**RE: SPILCA'S CHEVRON STATION - San Mateo & Indian School - (J18-D31).
DRAINAGE PLAN FOR BUILDING PERMIT APPROVAL. ENGINEER'S STAMP
DATED DECEMBER 21, 1999.**

***RE: SPILCA'S CHEVRON STATION - San Mateo & Indian School - (J18-D31).
DRAINAGE PLAN FOR BUILDING PERMIT APPROVAL. ENGINEER'S STAMP
DATED DECEMBER 21, 1999. ALSO STAMPED MARCH 20, 2000.***

RE: SPILCA'S CHEVRON STATION (J-18/D031)
(2124 San Mateo Blvd NE)
ENGINEERS CERTIFICATION FOR CERTIFICATE OF OCCUPANCY
ENGINEERS STAMP DATED 12/21/1999 Rev. 3/20/2000
ENGINEERS CERTIFICATION DATED 5/14/2001

GRADING AND DRAINAGE PLAN

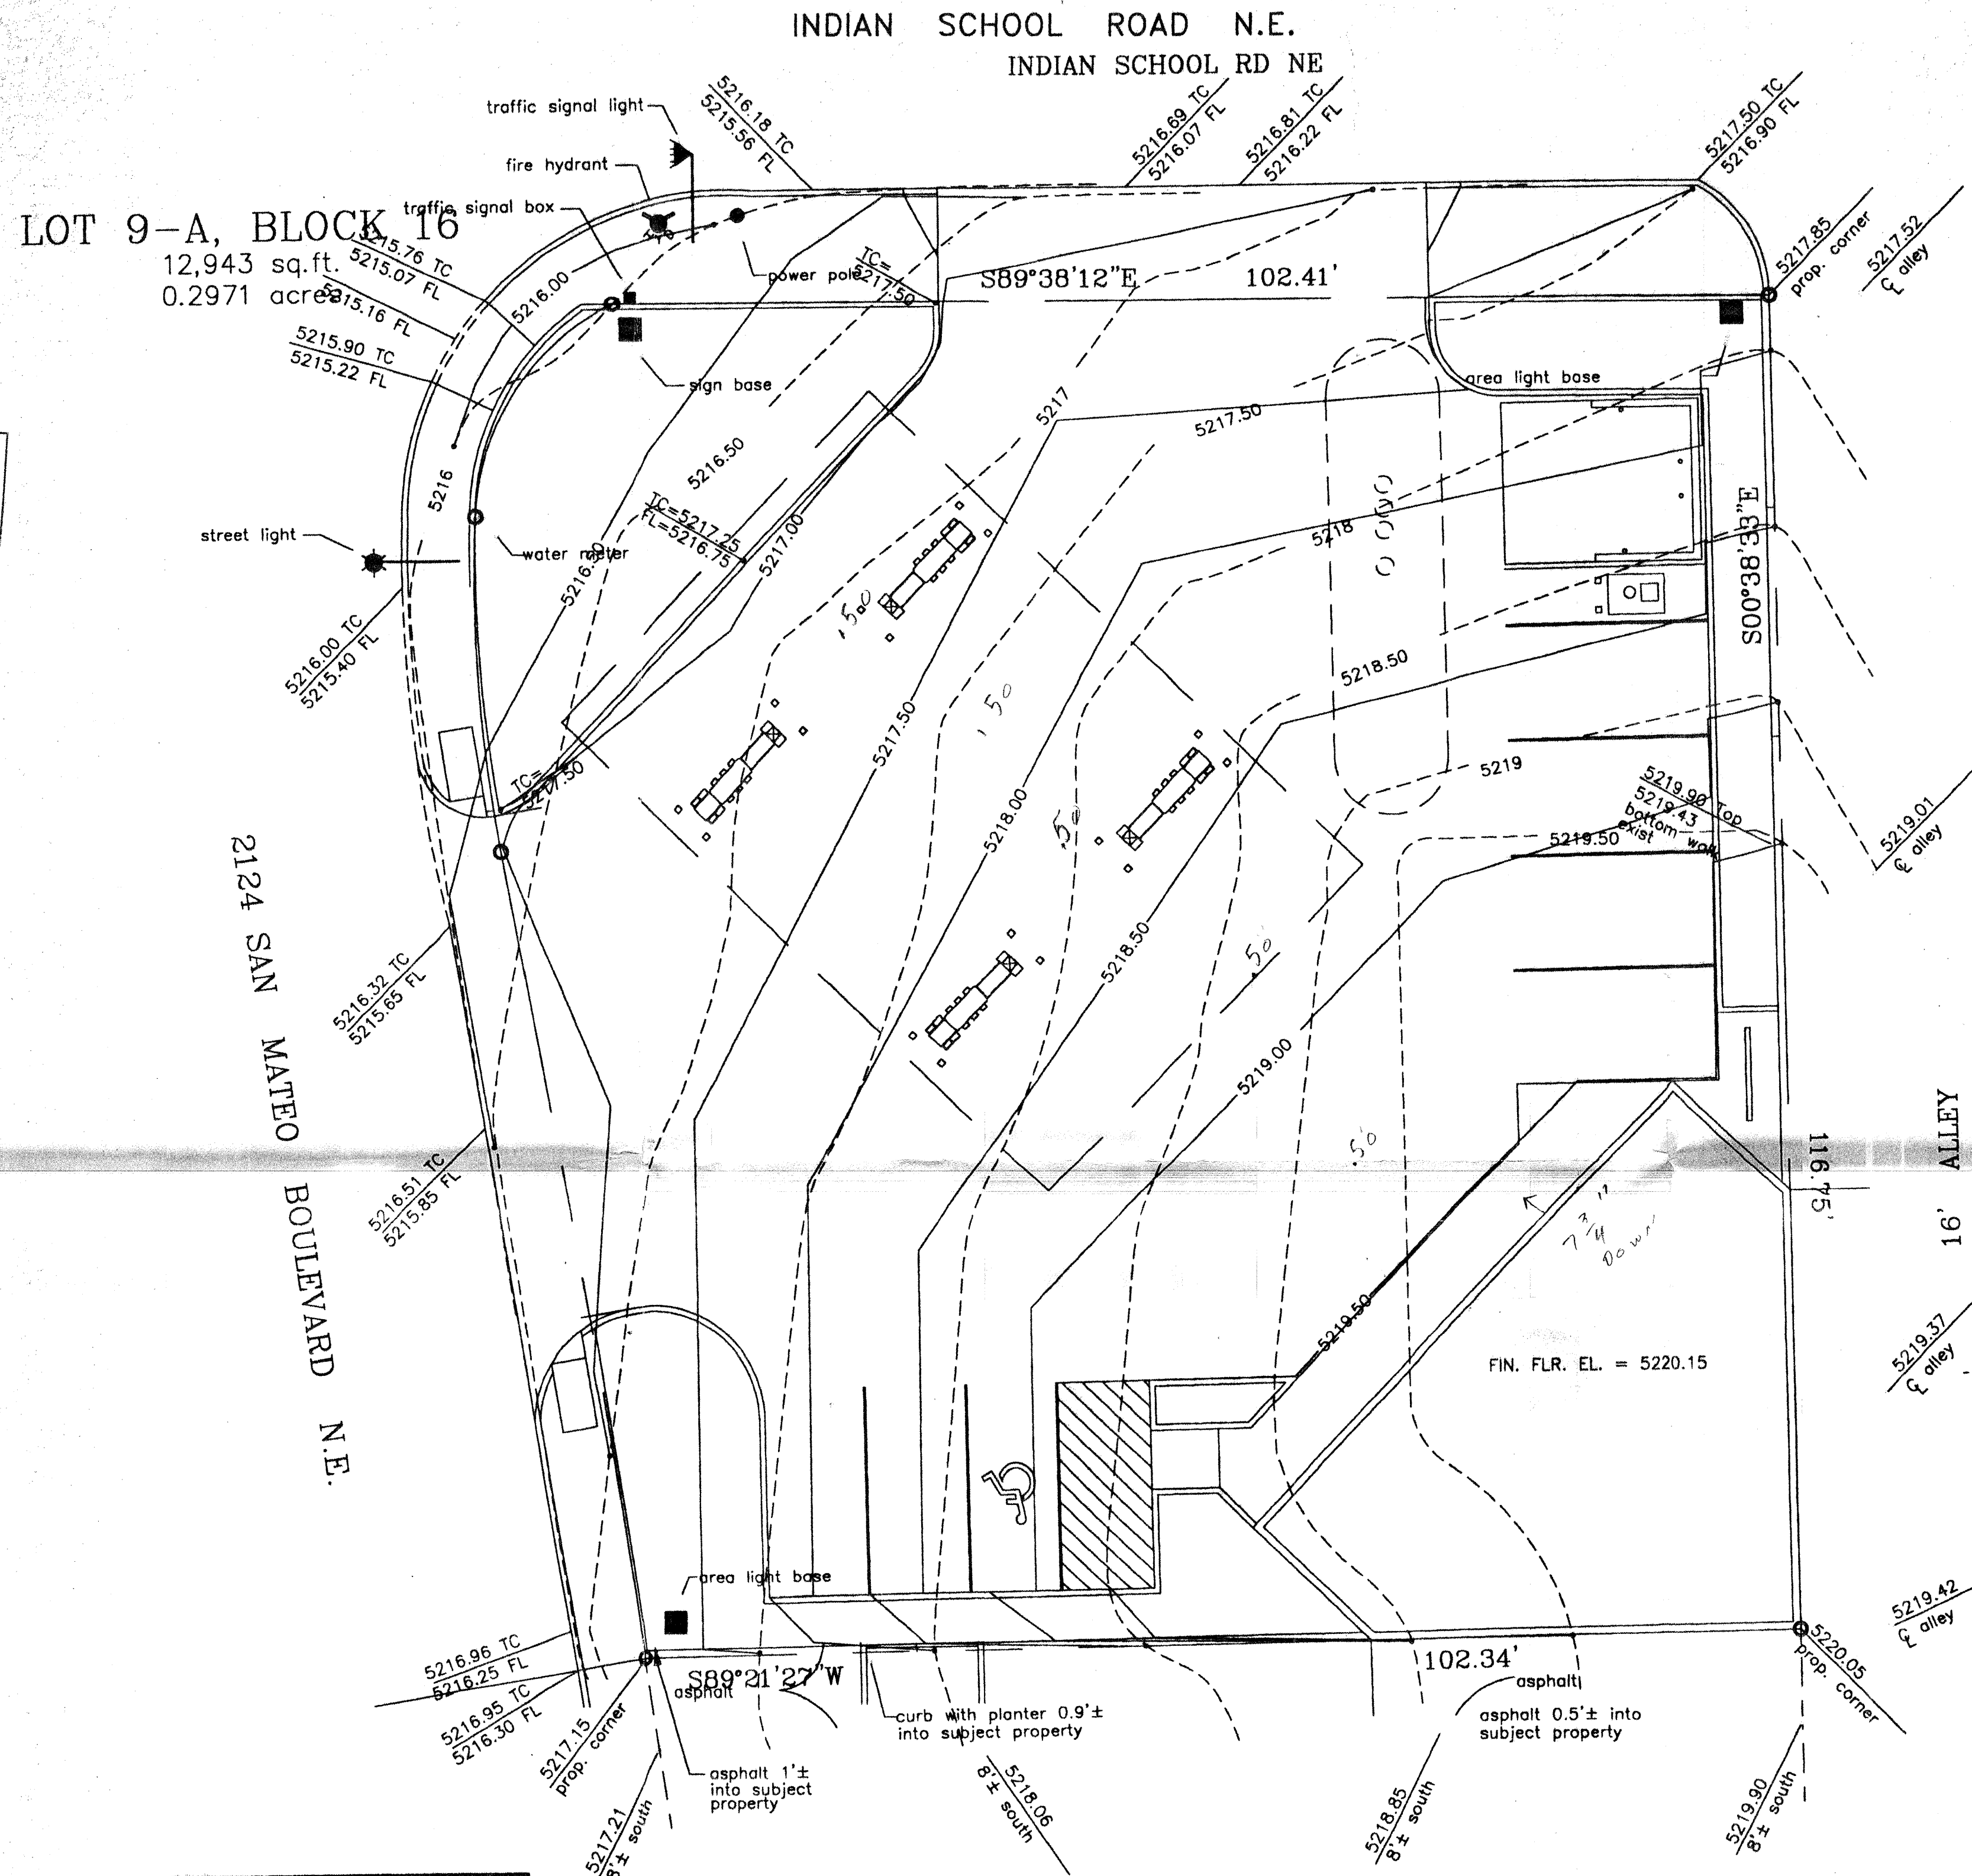
Delete the SO#19 notes and signature block from Sheet 1. There are no drainage facilities indicated in the City right-of-way. Note also that Zone Atlas is J-18 not H-17.

Based on the information provided on your March 24, 2000 resubmittal, the above referenced project is approved for Building Permit. The G&D Plan, still stamped December 21, 1999, removed reference to SO#19 Permit. The Site Plan dated March 20, 2000 adjusted drive pad locations.
